Private Fuel Storage, L.L.C.

**EIS COMMITMENT RESOLUTION LETTER #5
DOCKET NO. 72-22 / TAC NO. L22462
PRIVATE FUEL STORAGE FACILITY
PRIVATE FUEL STORAGE L.L.C.**

During the above referenced phone calls, between the NRC and Stone and Webster (S&W), the NRC requested clarification/additional information regarding several topics discussed in the PFS Environmental Report (ER). The NRC requests/questions are documented below along with the PFS response.

0599601-EY-3

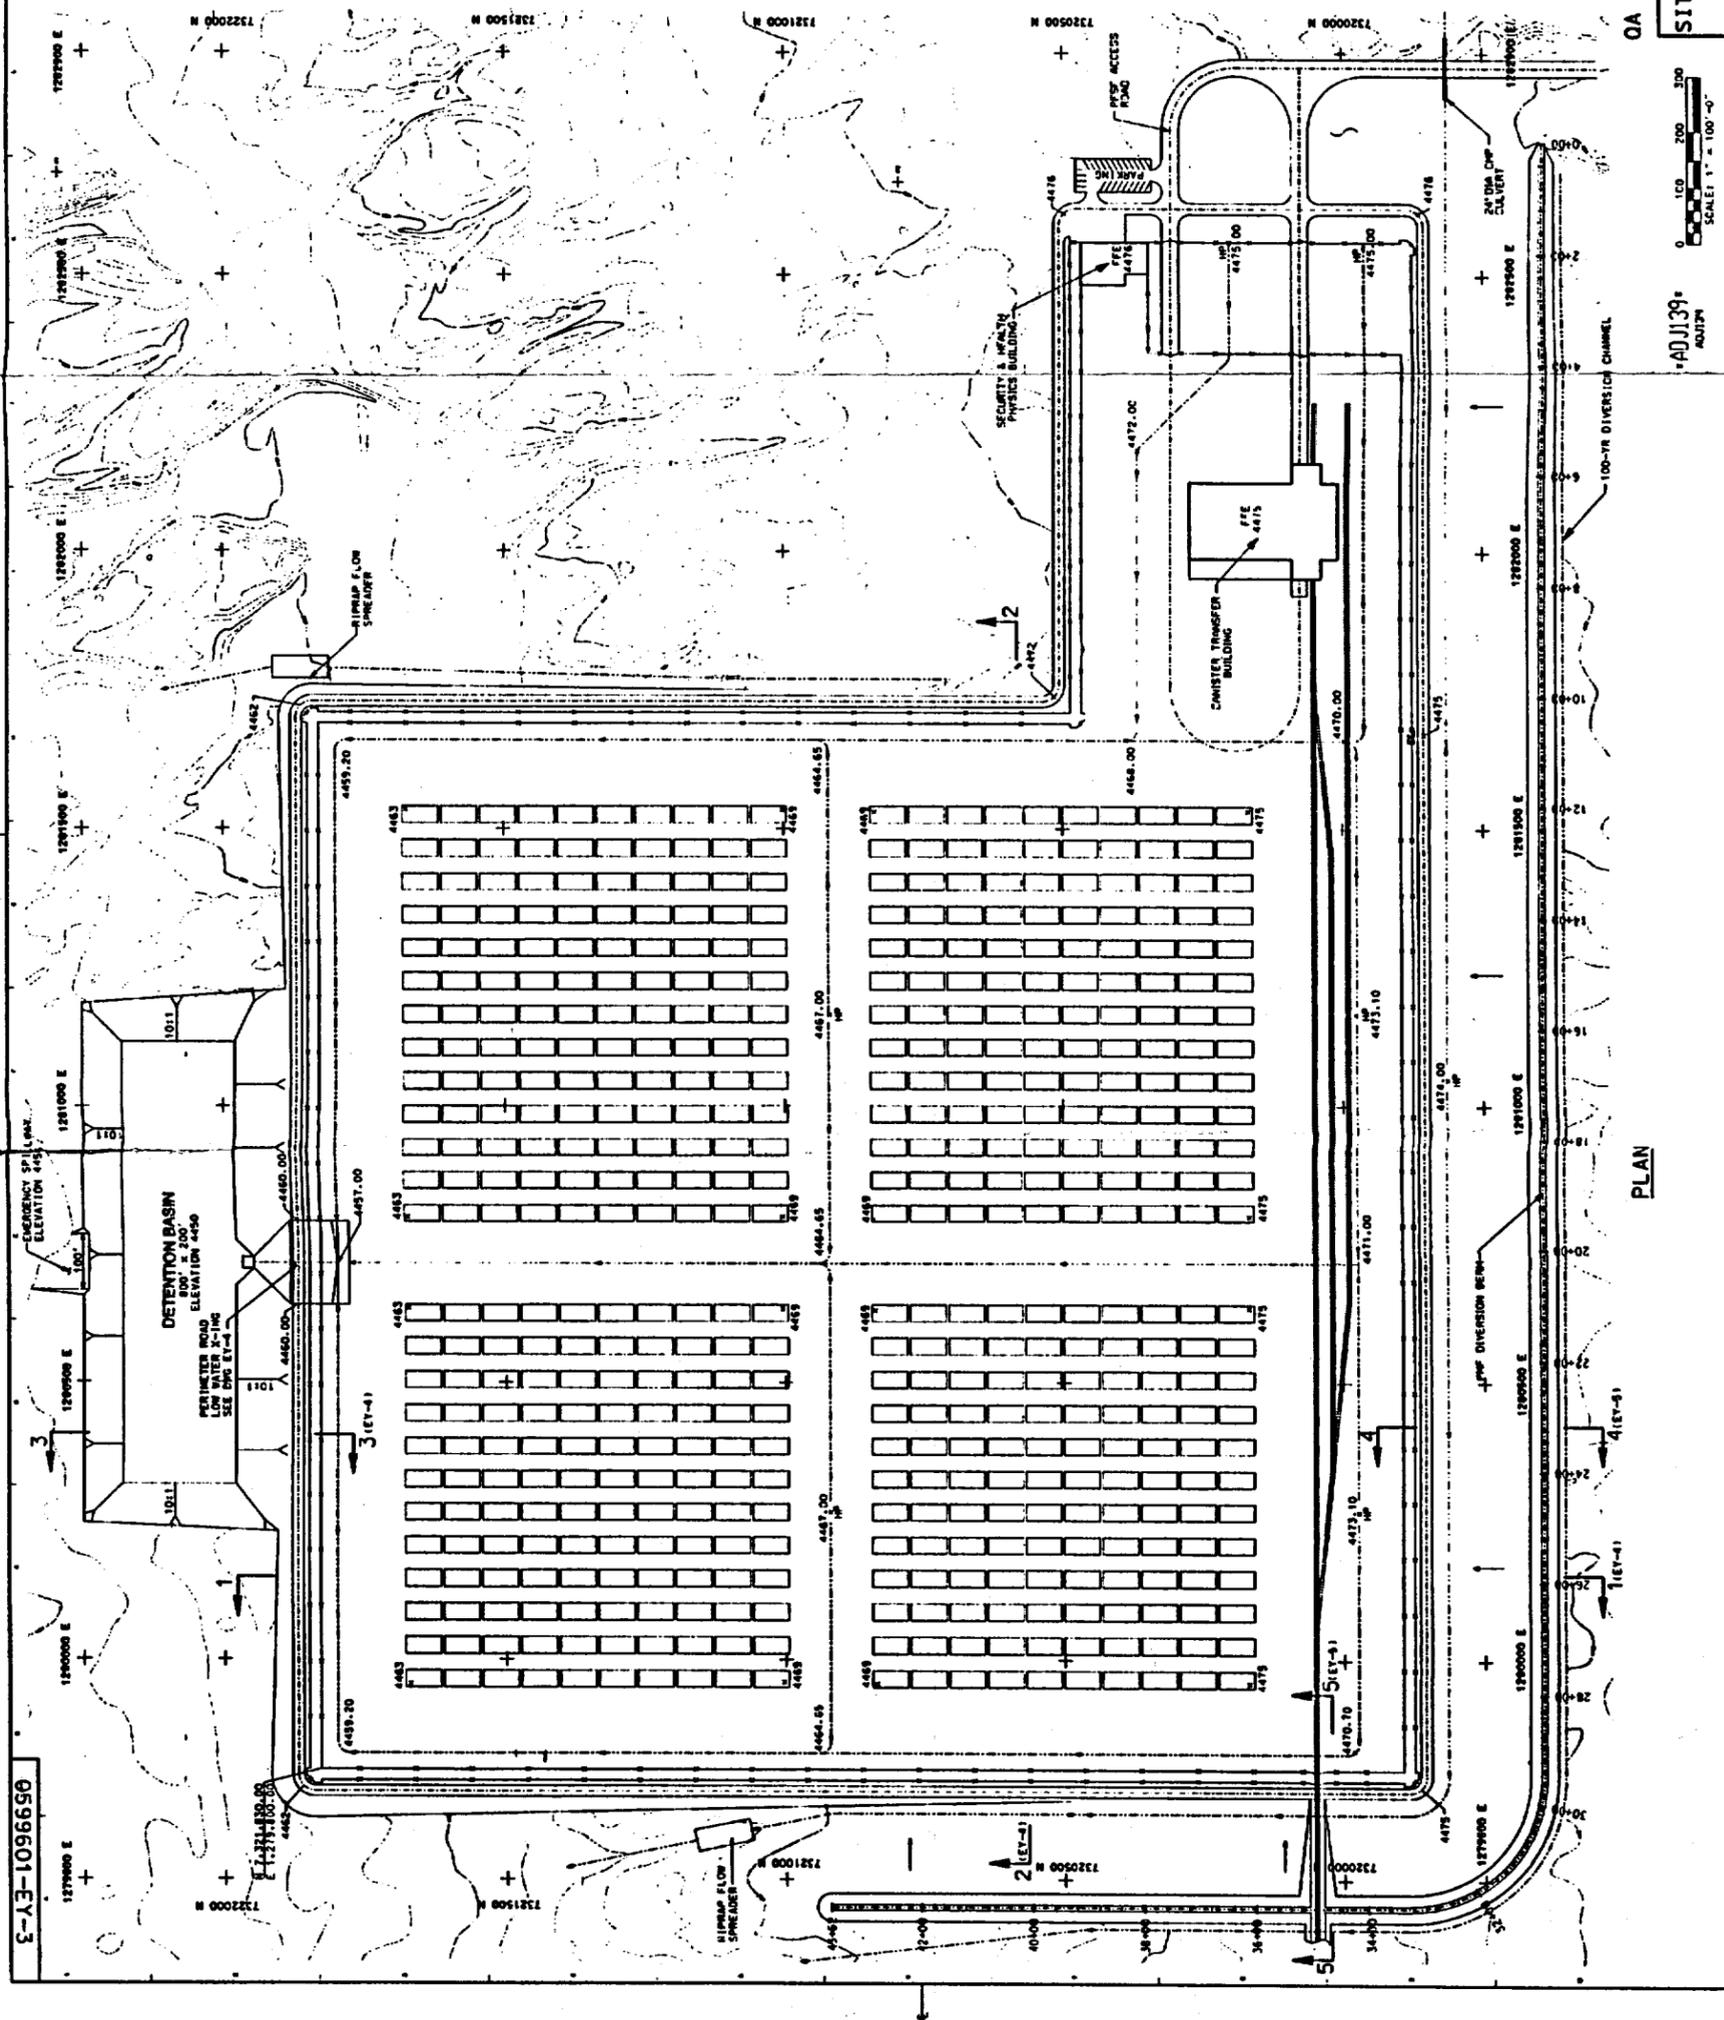
5. PFS needs to provide additional details on the construction of the Detention Basin. Include a discussion of what provisions will be taken to avoid wind and water erosion

of side slopes and provide any drawings that PFS has that shows the design of the basin.

RESPONSE - The detention basin is shown on drawings 0599601-EY-3 and 0500601-EY-4 (see attached copy). The 800' x 200' detention basin located immediately north of the storage area is designed to contain the 100-yr flood. The basin is designed with a concrete inlet from the storage site that precludes erosion from site drainage. The basin is constructed of compacted soil with 10 to 1 side slopes. Side slopes this gradual will reduce the velocity of rainwater flowing into the basin and minimize wind pressure thereby reducing the potential for wind or water erosion. In addition, the basin is located within the 300 wide wildfire barrier that will be planted with crested wheat grass. The presence of the crested wheat grass on the side slopes and bottom of the basin will stabilize the soil and help prevent erosion due to wind or water.

The detention basin is not expected to have standing water except possibly following a severe rainstorm. Water drainage from the storage site from a typical rainstorm is estimated to soak into the ground before it reaches the detention basin. The detention basin was sized for a 100-year flood event in which the depth of water in the basin was calculated to be 4.77 ft. (S&W Calculation No. 0599601-SY-2, Revision 0). In the unlikely event of a 100-yr flood, the time for the water that has collected in the basin to be removed via evaporation and ground percolation is approximately 140 days assuming an evaporation rate of 0.32 in/day (Houghton, Handbook of Applied Meteorology, 1985) and percolation rate of 0.09 in/day (Lambe & Whitman, Soil Mechanics, 1969). If this unlikely event occurred, temporary pumps would be used to drain the detention basin and eliminate long term standing water.

Figure 4.1-1
AGGREGATE SOURCES
 PRIVATE FUEL STORAGE FACILITY
 ENVIRONMENTAL REPORT

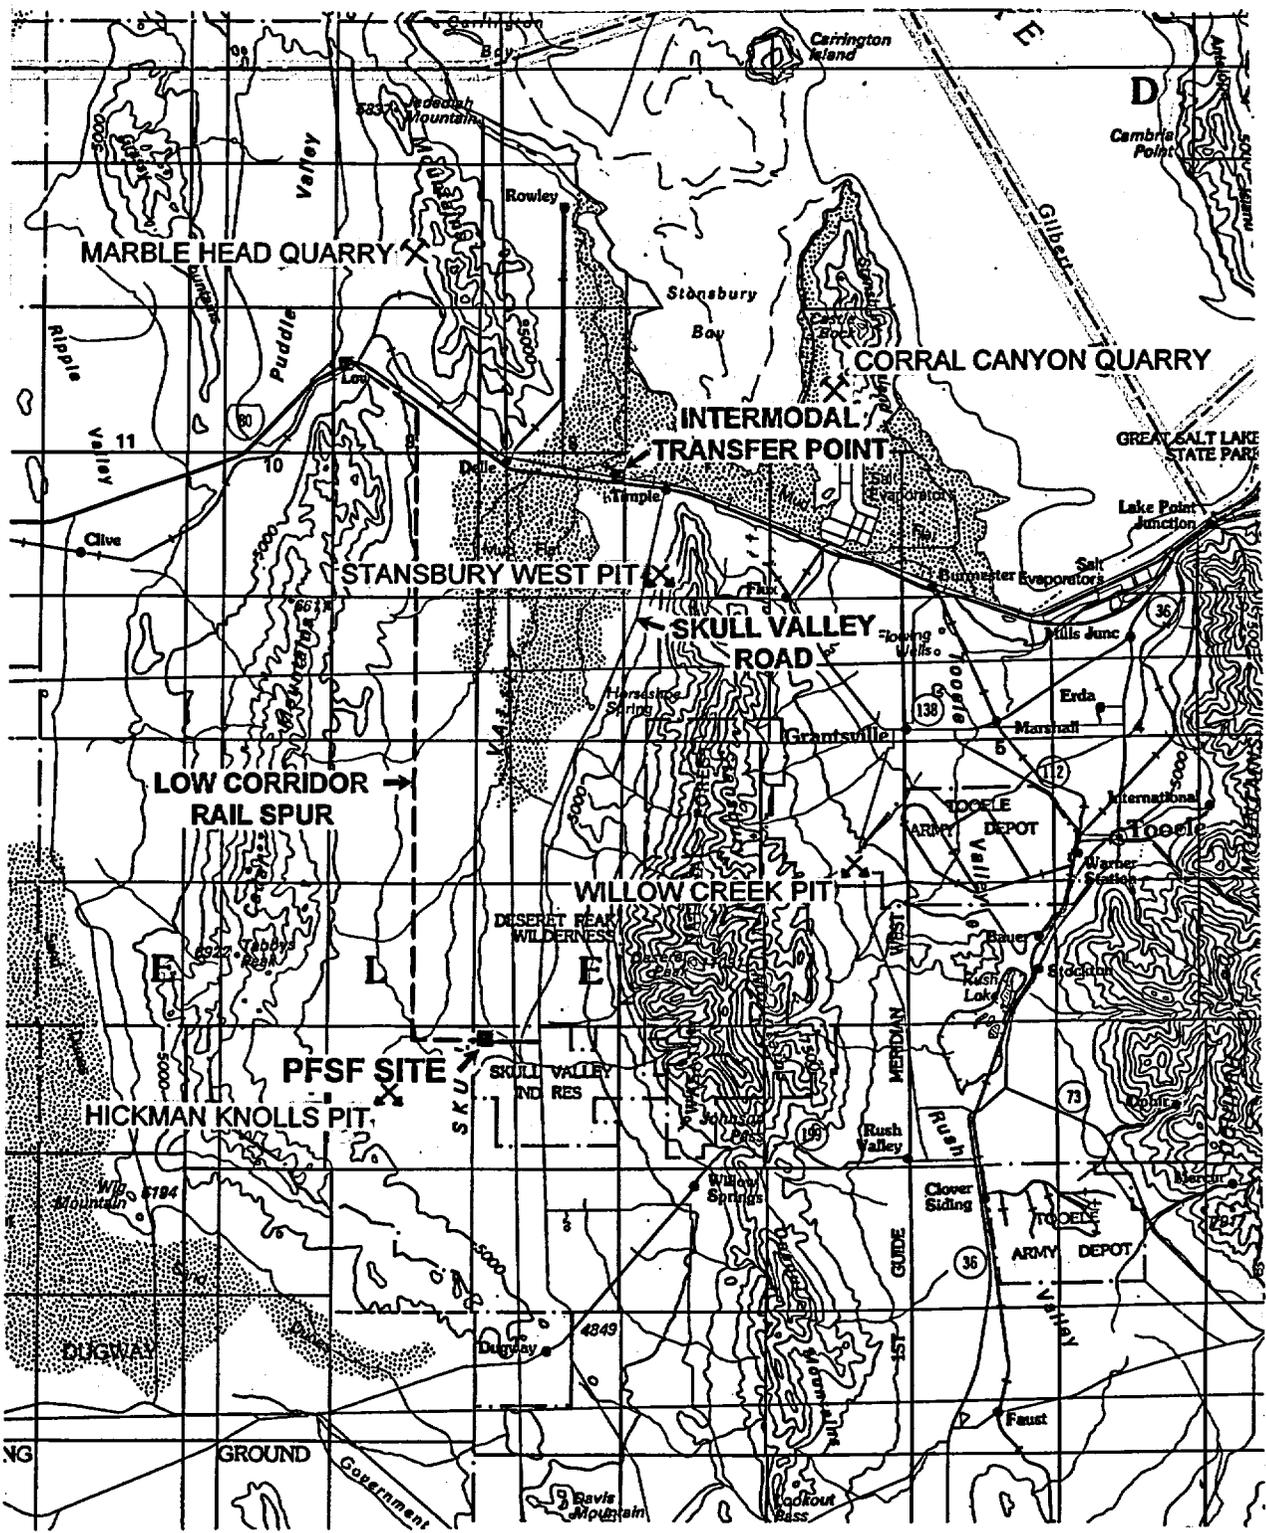
8. PFS should provide a map that shows the location of the aggregate sites in Skull Valley presented in ER Table 4.1-7. Additional information should be provided as to the operational status of each site and the permitting requirements/status of each site.

RESPONSE - A map showing the location of the nearby privately owned aggregate sites as listed in ER Table 4.1-7 is attached and will be incorporated into the next ER revision. For sand and gravel material, currently only the Willow Creek pit is in operation. However, the Stansbury West pit and Hickman Knolls pit can be reopened to provide necessary materials. For the railroad line ballast, only the Corral Canyon Quarry is in operation but the Marble Head Quarry can be reopened to provide ballast materials.
